**Global Forum for Road Traffic Safety**

**Convention on Road Signs and Signals (1968)**

### **Proposal for amendments to Annex 1 and 3**

**Submitted by the Group of Experts on Road Signs and Signals**

### OPENING BRIDGE

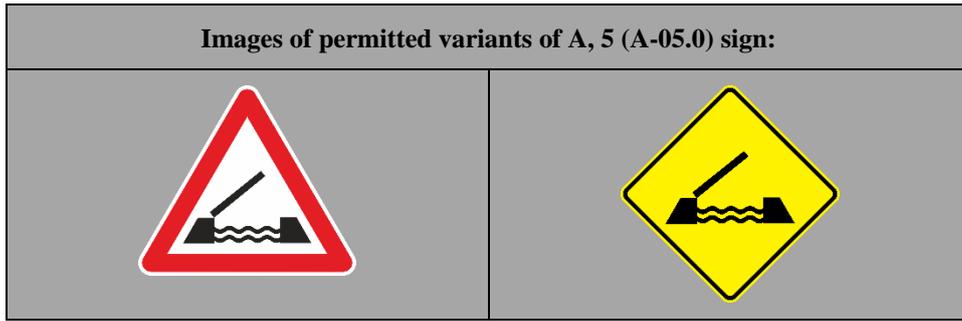
(a) ~~Warning of an opening bridge shall be given by the symbol A, 5.~~

**A, 5 (A-05.0) gives warning of an opening bridge.**

(b) ~~A rectangular panel of model~~ **The sign A, 29a (A-26.1)** described in paragraph 29 below may be placed below ~~this sign~~ **the danger warning sign bearing symbol A, 5** provided that ~~panels of model signs A, 29b and A, 29c (A-26.2 and A-26.3)~~ **panels of model signs A, 29b and A, 29c (A-26.2 and A-26.3)** described in that paragraph are set up at approximately one third and two thirds of the distance between ~~the the sign A29a bearing symbol A, 5~~ **the the sign A, 5** and the opening bridge.

**SLIPPERY ROAD**

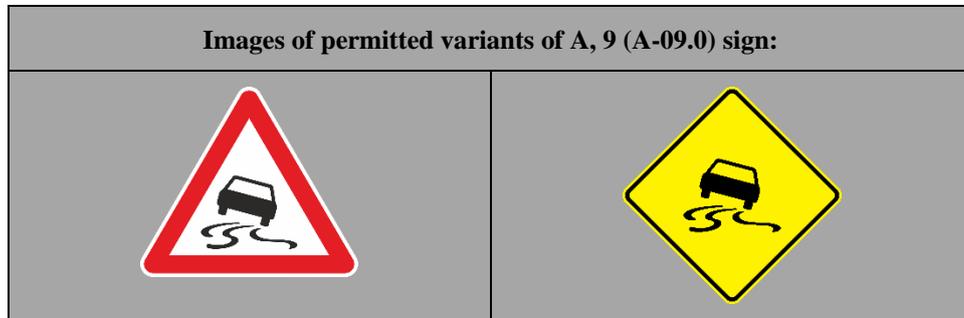
~~Warning that the section of road ahead may be particularly slippery shall be given by symbol A, 9~~

**A, 9 (A-09.0) gives warning that the section of road ahead may be particularly slippery.**

**LOOSE GRAVEL**

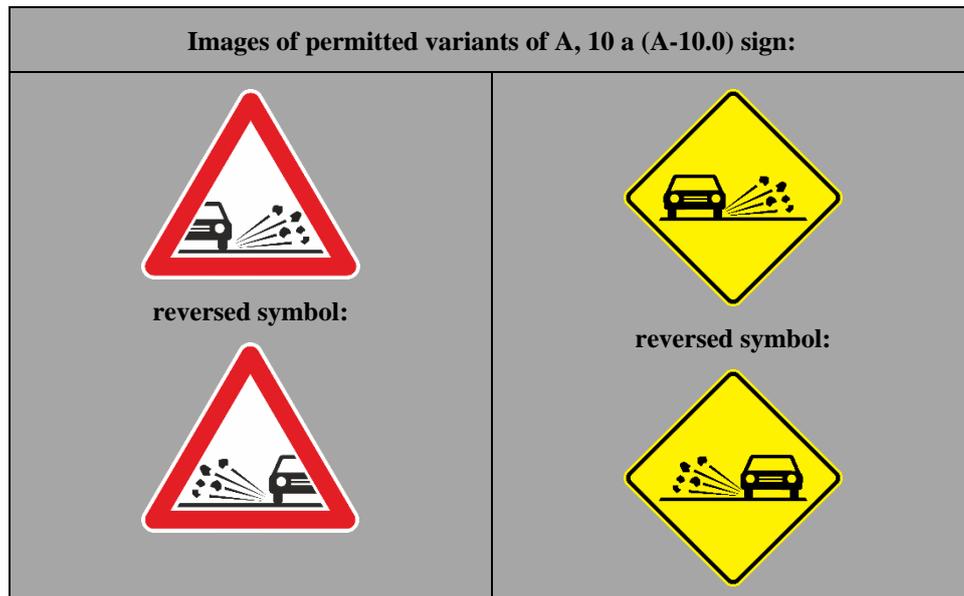
~~Warning of a section of road on which gravel may be thrown up shall be given by symbol A, 10a used with the sign of model Aa or by symbol A, 10b with the sign of model Ab.~~

**A, 10 a (A-10.0) gives warning of a section of road on which gravel may be thrown up. The symbol on this sign may be reversed.**

**FALLING ROCKS**

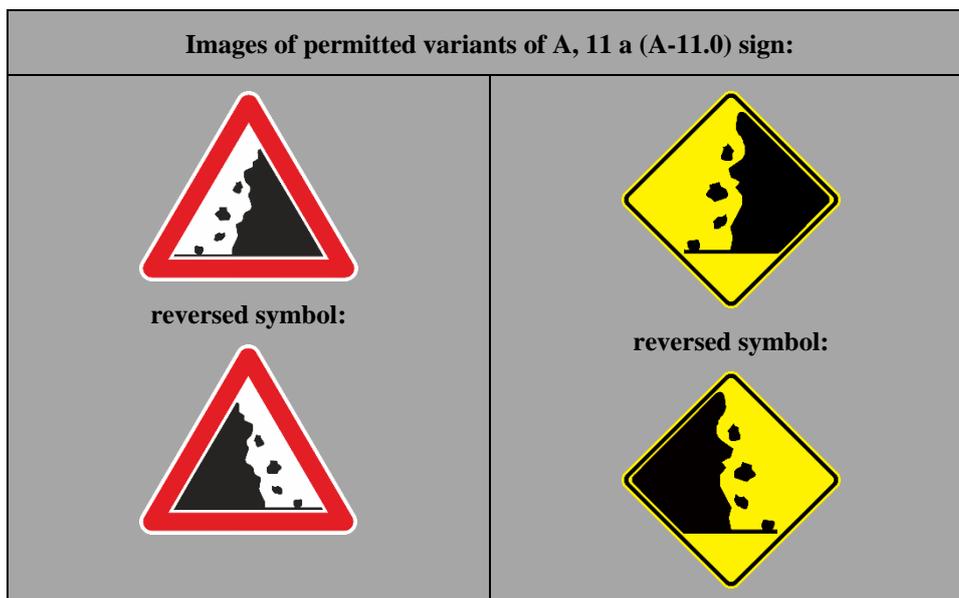
~~(a) Warning of a section of road on which there is danger from falling rocks and the consequent presence of rocks on the carriageway shall be given by symbol A, 11a used with the sign of model Aa or by symbol A, 11b with the sign of model Ab.~~

~~(b) The right hand part of the symbol shall occupy the right hand corner of the sign panel in both cases.~~

~~(c) The symbol may be reversed.~~

A, 11 a (A-11.0) gives warning of a section of road on which there is danger from falling rocks and the consequent presence of rocks on the carriageway. The symbol on this sign may be reversed.

### PEDESTRIAN CROSSING

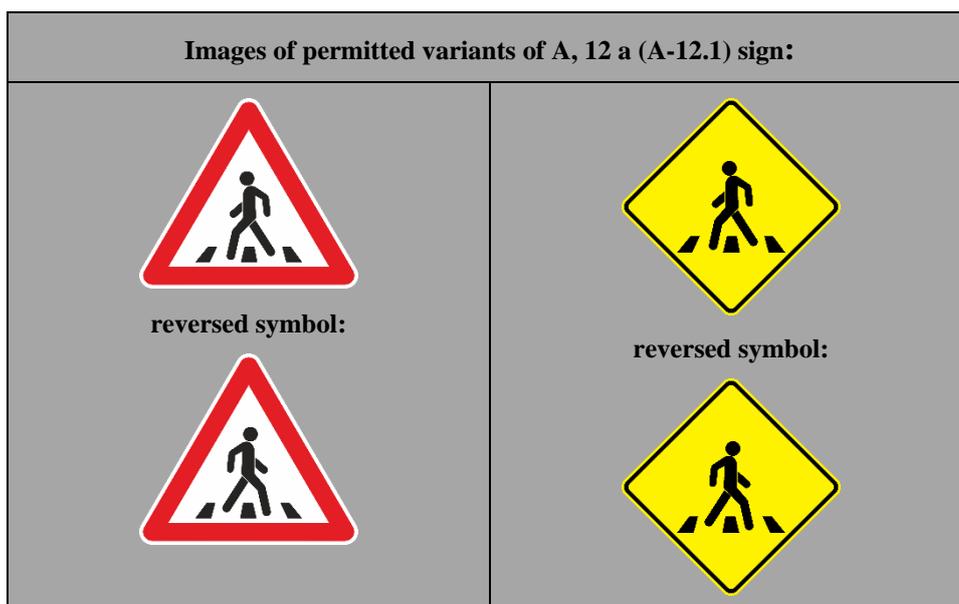
(a) ~~Warning of a pedestrian crossing indicated either by road markings, or by signs E, 12 shall be given by symbol A, 12 of which there are two models: A, 12a and A, 12b.~~

(b) ~~The symbol may be reversed.~~

A, 12 a (A-12.1) gives warning of a pedestrian crossing indicated either by road markings of broad stripes parallel to the axis of the carriageway, or by sign E, 12 (E-10.0). The symbol on this sign may be reversed.

### ROAD WORKS

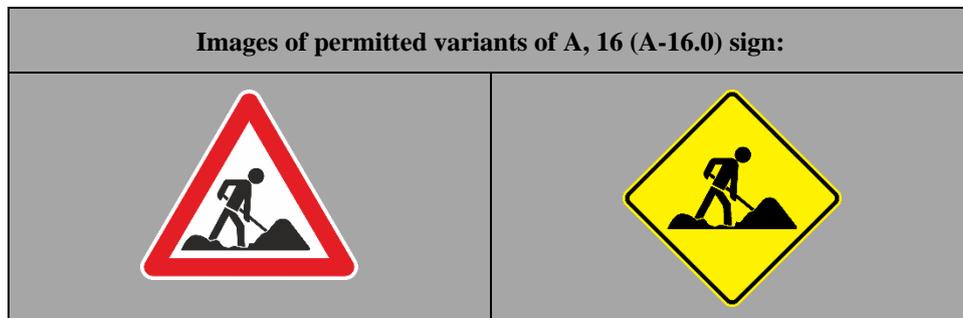
~~Warning that work is in progress on the section of the road ahead shall be given by symbol A, 16.~~

A, 16 (A-16.0) gives warning that work is in progress on the section of the road ahead.

### TRAFFIC LIGHT SIGNALS

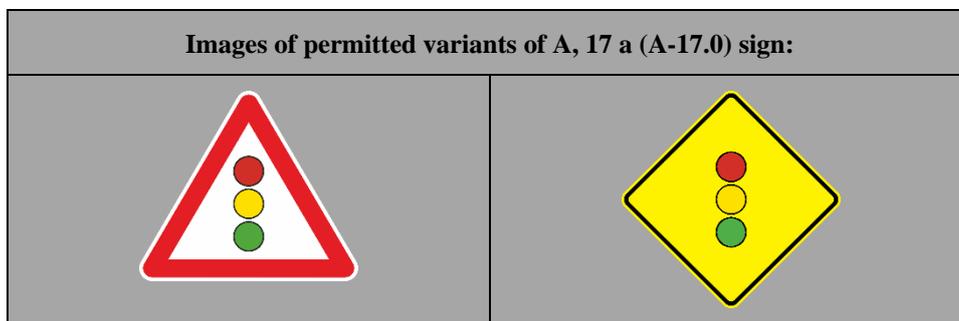
~~(a) If it is considered essential to give warning of a section of road on which traffic is regulated by three colour light signals, because road users would not expect such a section, symbol A, 17 shall be used. There are three models of symbol A, 17: A, 17a ; A, 17b ; and A, 17c , which correspond to the arrangements of lights in the three colour system described in Article 23, paragraphs 4 to 6 of this Convention.~~

~~(b) This symbol shall be in the three colours of the lights of which it gives warning.~~

A, 17 (A-17.0) gives warning of a section of road on which traffic is regulated by three-colour traffic light signals. The symbol of traffic light signals shall be surrounded by a dark colour narrow strip.

This sign shall only be used on road sections on which road users would not expect traffic light signals. The symbol shall be in the three colours of the traffic lights of which it gives warning.

This sign may be set up to supplement or replace the signs described in paragraphs 18 to 21 if traffic at the intersection is regulated by a traffic light signal.

**INTERSECTION WITH A GIVE WAY ROAD**

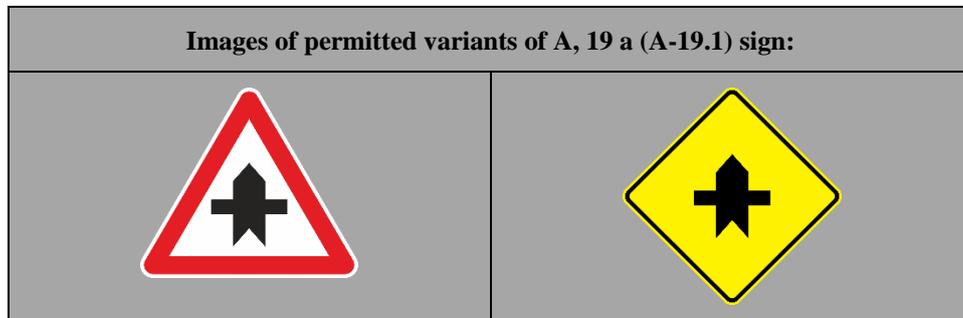
~~(a) Warning of an intersection with a road the users of which must give way shall be given by symbol A, 19a.~~

**A, 19 a (A-19.1) gives warning of an intersection with a road the users of which must give way.**

## ROUNDABOUT

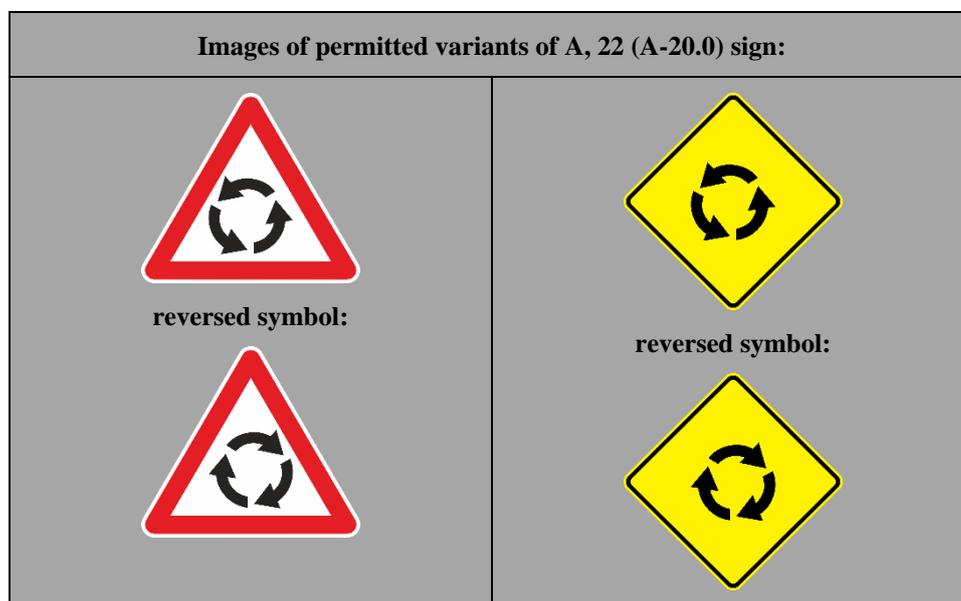
~~Warning of a roundabout shall be given by symbol A, 22.~~

## TWO-WAY TRAFFIC

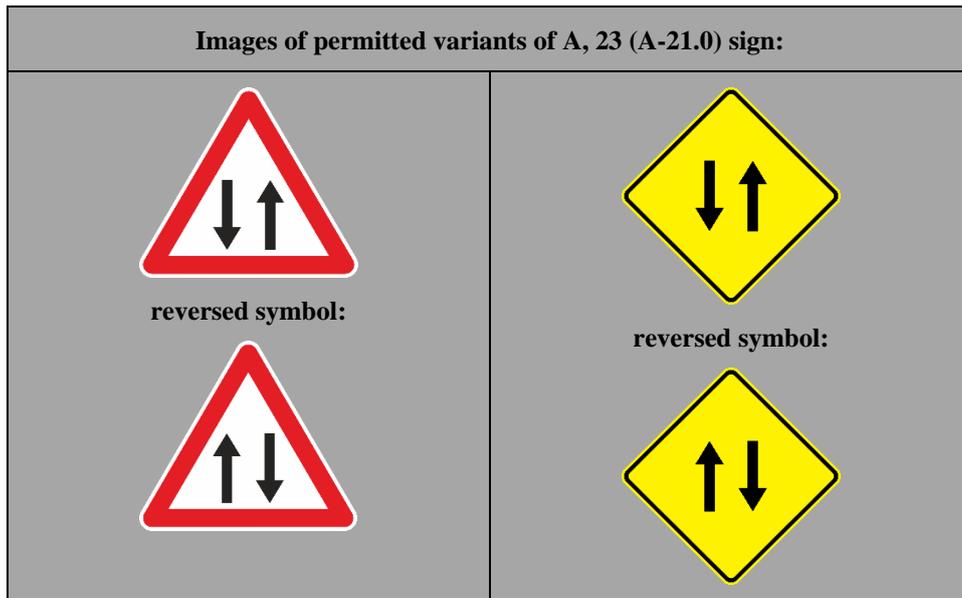
(a) ~~Warning of a section of road temporarily or permanently carrying two-way traffic on the same carriageway when, on the previous section, traffic was carried on a one-way road or on a road comprising several one-way traffic carriageways, shall be given by the symbol A, 23.~~

**TRAFFIC CONGESTION**

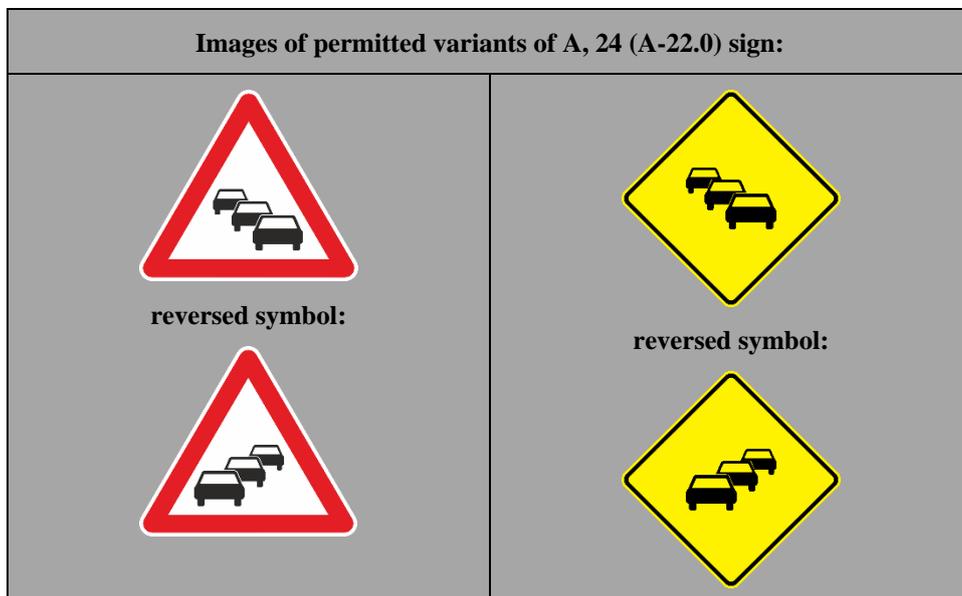
~~(a) Warning that there may be traffic congestion on the section of road ahead shall be given by symbol A, 24.~~

**LEVEL-CROSSINGS WITH GATES**

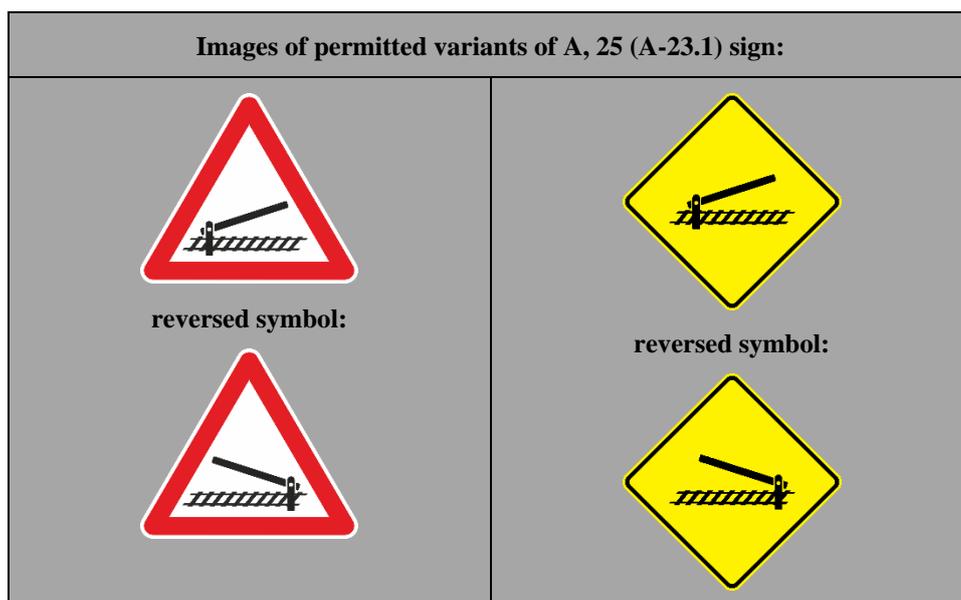
~~Warning of level crossings with gates or staggered half gates on either side of the railway line, shall be given by symbol A, 25.~~

**CROSS-WIND**

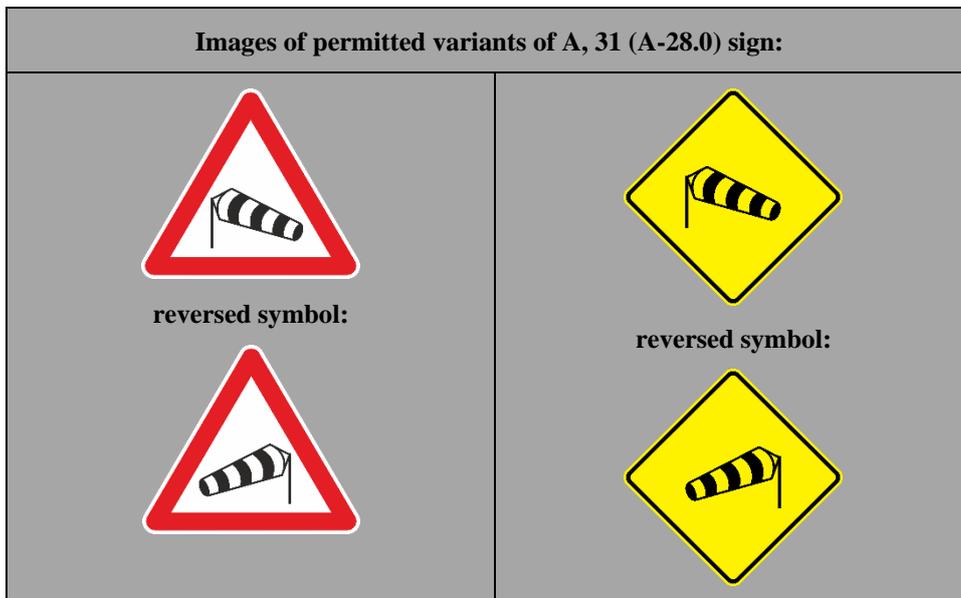
~~(a) Warning of a section of road on which there is often a strong cross wind shall be given by symbol A, 31.~~

**OTHER DANGERS**

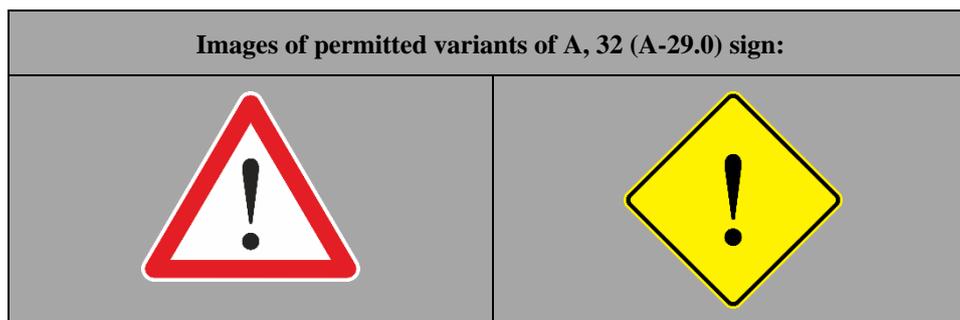
~~(a) Warning of a section of road on which there is a danger other than those enumerated in paragraphs 1 to 31 above or in section B of this annex may be given by symbol A, 32.~~

**PROHIBITION OF OVERTAKING**

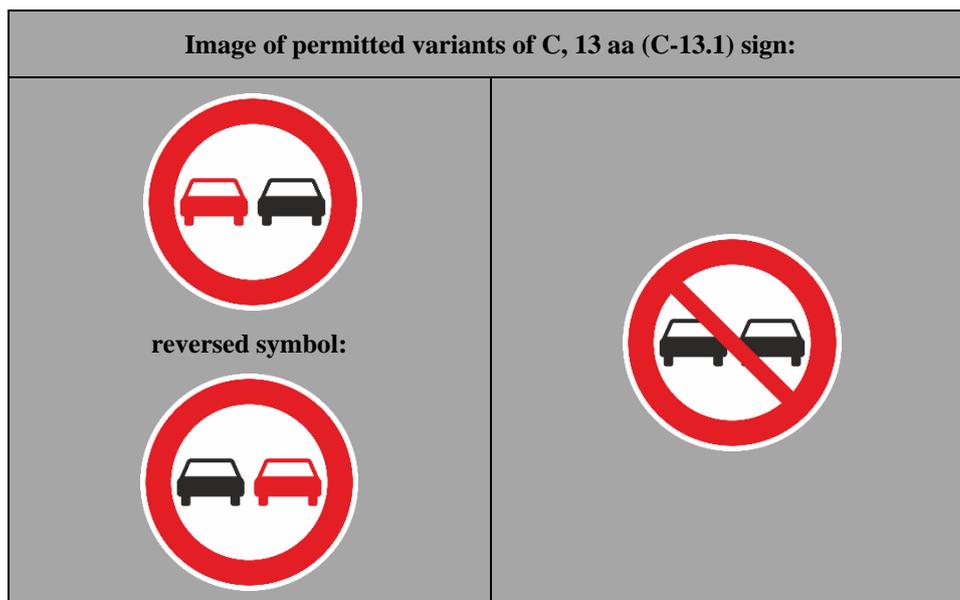
**C, 13 aa (C-13.1) notifies** ~~(a) Notification that, in addition to the general rules on overtaking laid down by the regulations in force, the overtaking of power-driven vehicles other than two-wheeled mopeds and two-wheeled motor cycles without side-car travelling on a road is prohibited., shall be given by sign C, 13a "OVERTAKING PROHIBITED".~~ **The symbol on this sign shall be reversed, if necessary, for traffic keeping to the left. Contracting Parties shall select a variant of this sign with or without the red oblique bar.**
